Specific Site Assessment for Coal Combustion Waste Impoundments at Duke Energy Carolinas Lee Steam Station

Williamston, South Carolina

Submitted to:

LEE STEAM STATION - ASH BASIN Primary Dike @ STA 6+00

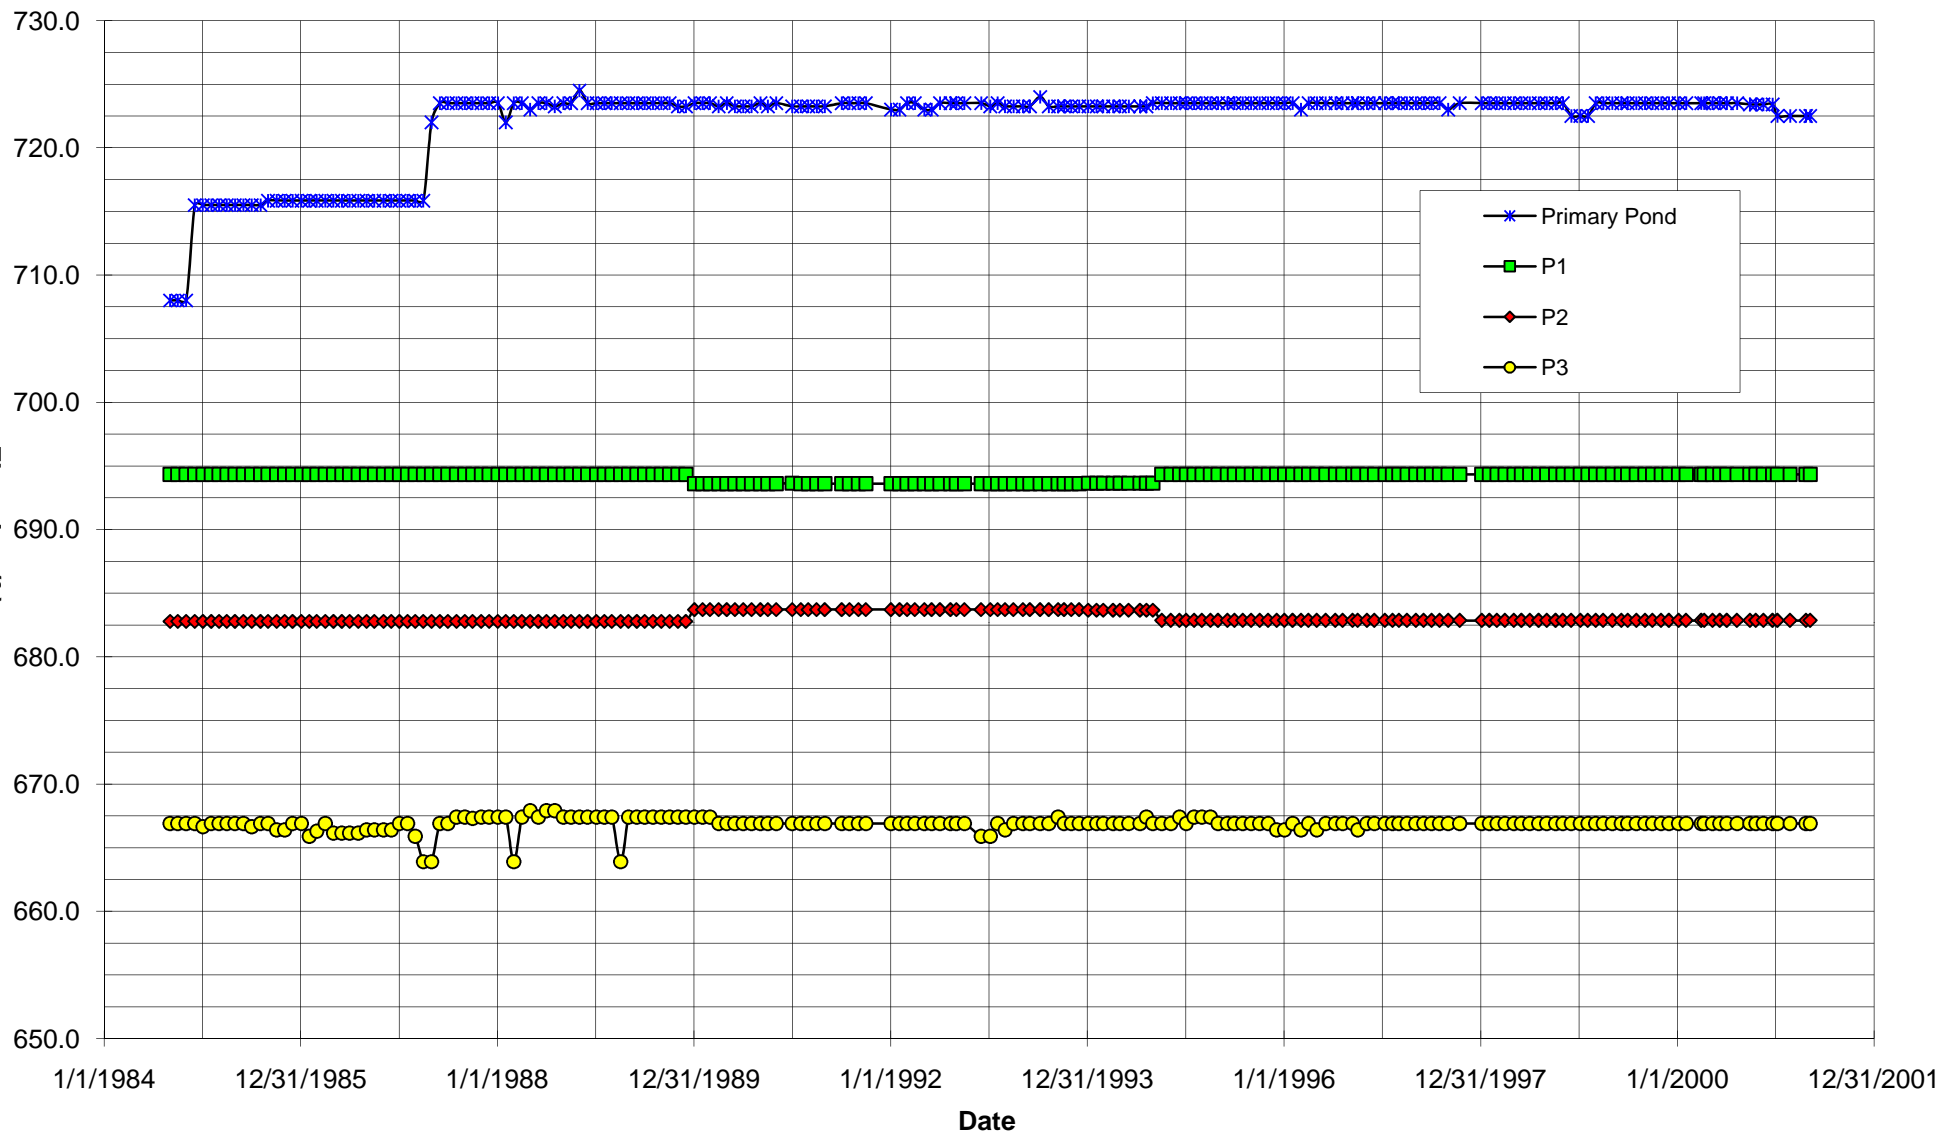
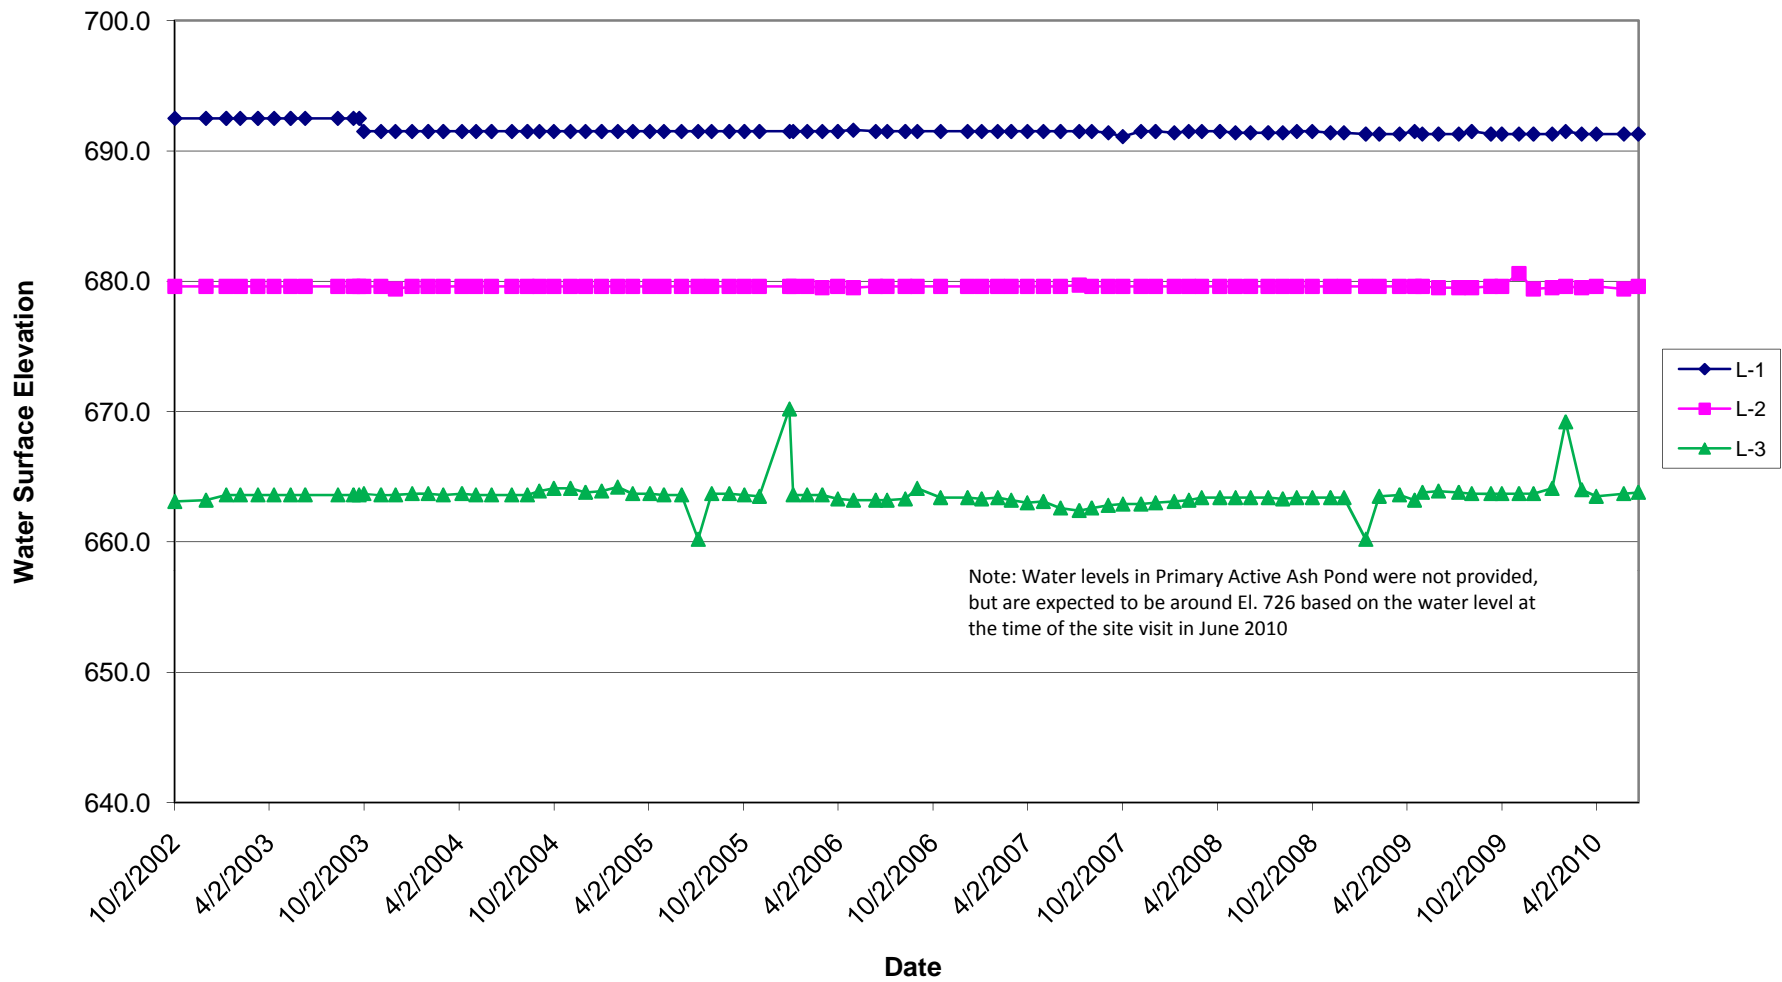
The water levels in piezometers L-1, L-2 and L-3, near the left abutment of the Primary Active Ash Pond dam, have remained relatively steady with time. The water level in piezometer L-3, at the dam toe, rose 6 to 7 feet in December 2005 and February 2010, but returned back to consistent levels in subsequent readings. The cause for these erratic readings is unknown.

The instrumentation installed at the Lee Steam Station CCW impoundments is functioning properly, and the frequency of readings is considered adequate. High water levels have been measured in piezometers L-4 (between August 2009 and April 2010) and L-9 (compared with the other piezometers near the dam toe). The cause of these readings should be investigated.

LEE STEAM STATION - ASH BASIN Primary Dike @ STA 13+10

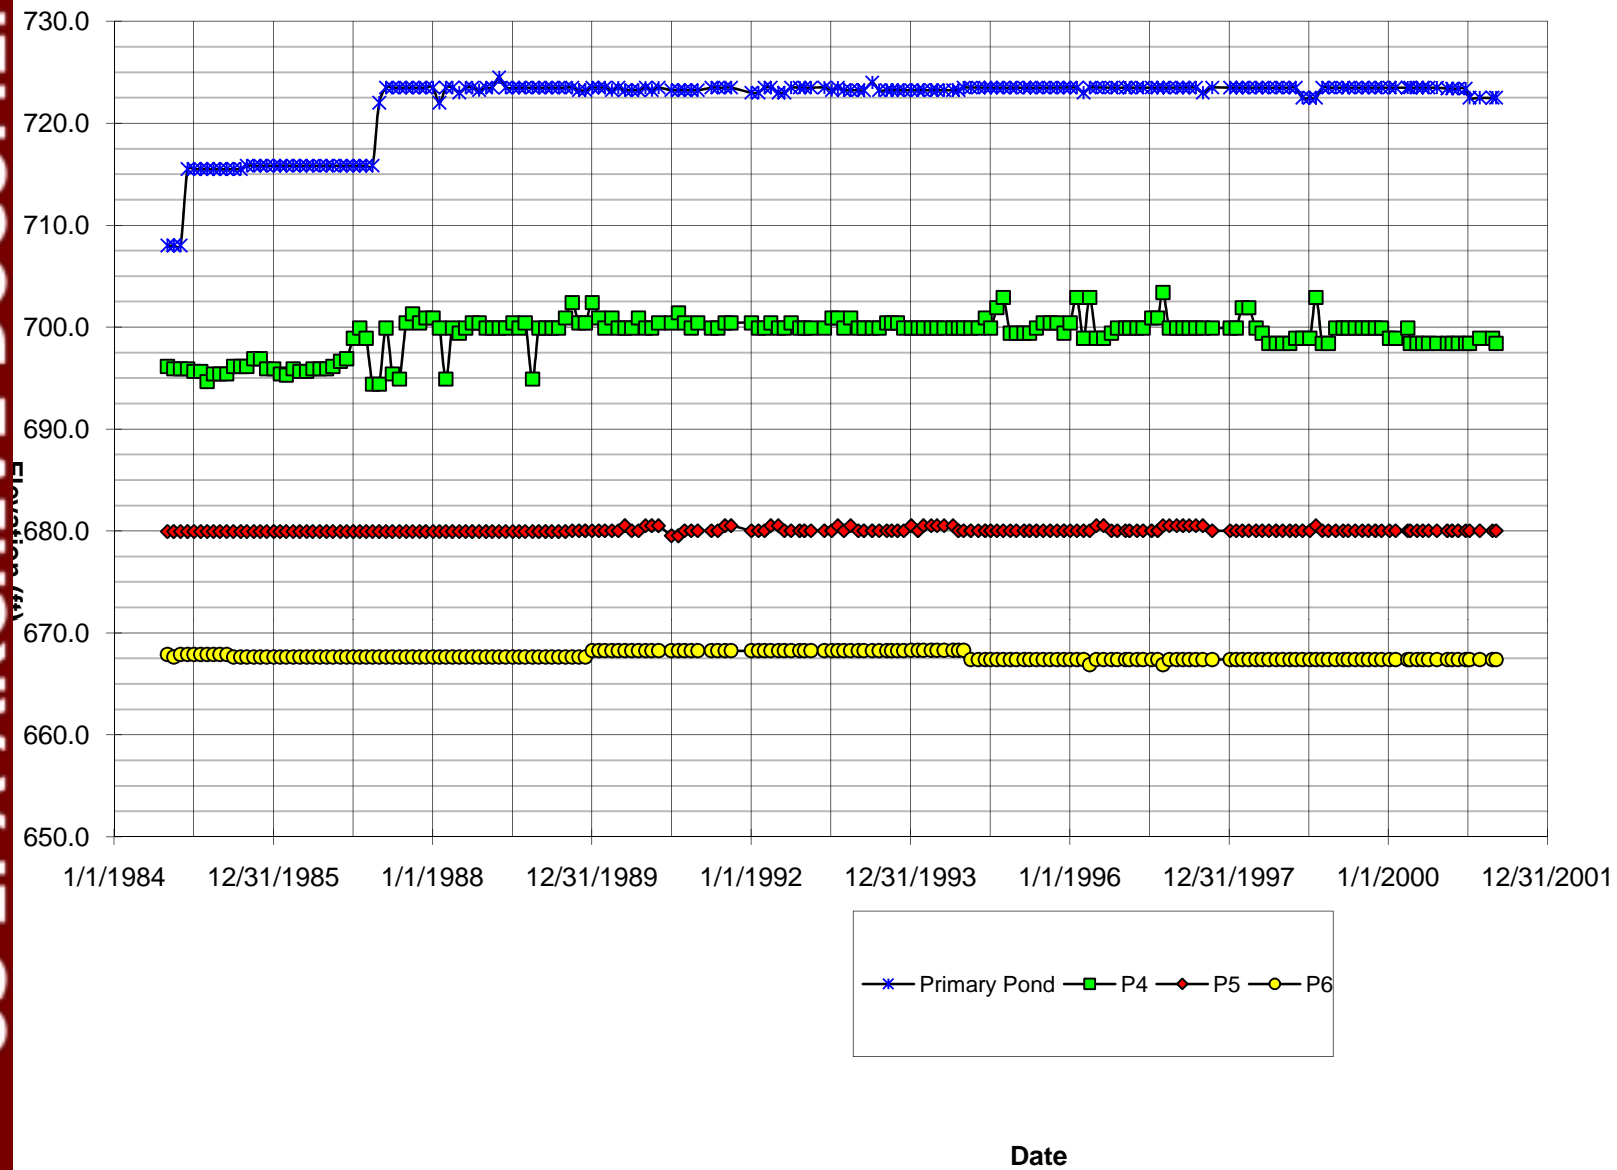
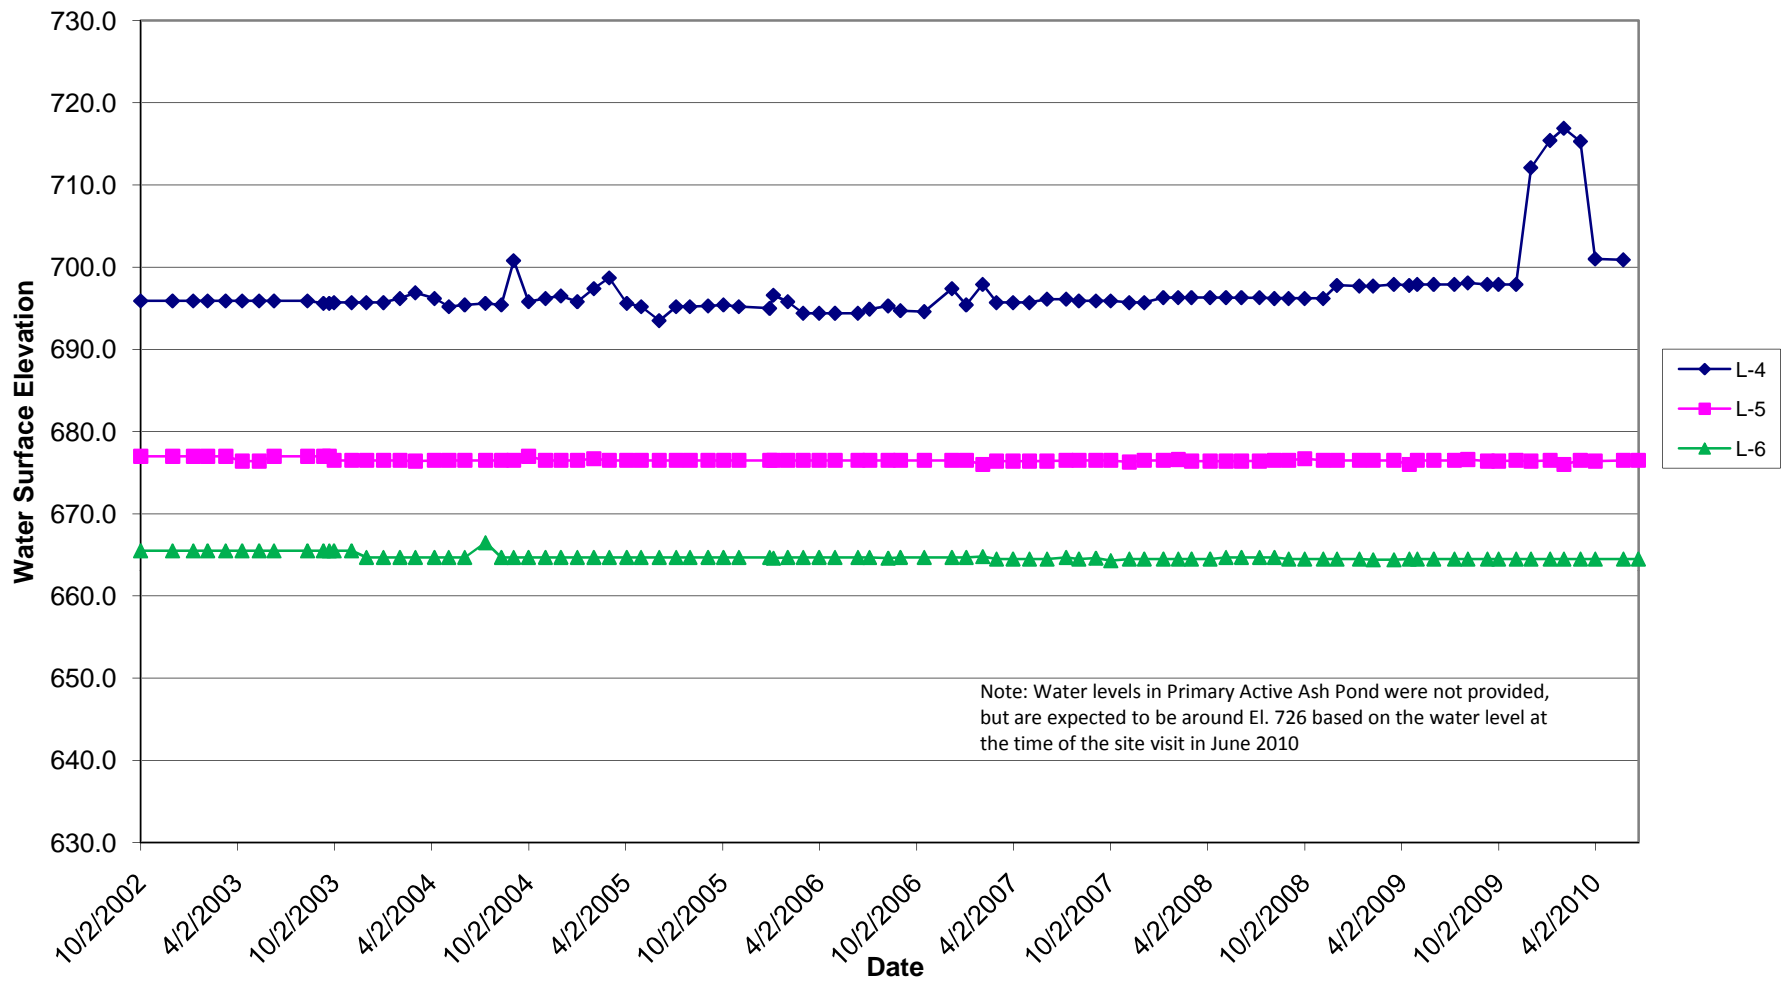
The water levels in piezometers L-5 and L-6, the lower two piezometers near the right abutment of the Primary Active Ash Pond dam, have remained relatively steady with time. The water level in piezometer L-4, near the dam crest, fluctuated regularly within several feet until around 2007. From 2007 until August 2009, the water level in L-4 rose steadily, and

between December 2009 and April 2010 it rose about 17 feet. In April 2010 the water fell back to within several feet of its previous levels. The cause for the sudden rise in water level in piezometer L-4 is unknown.
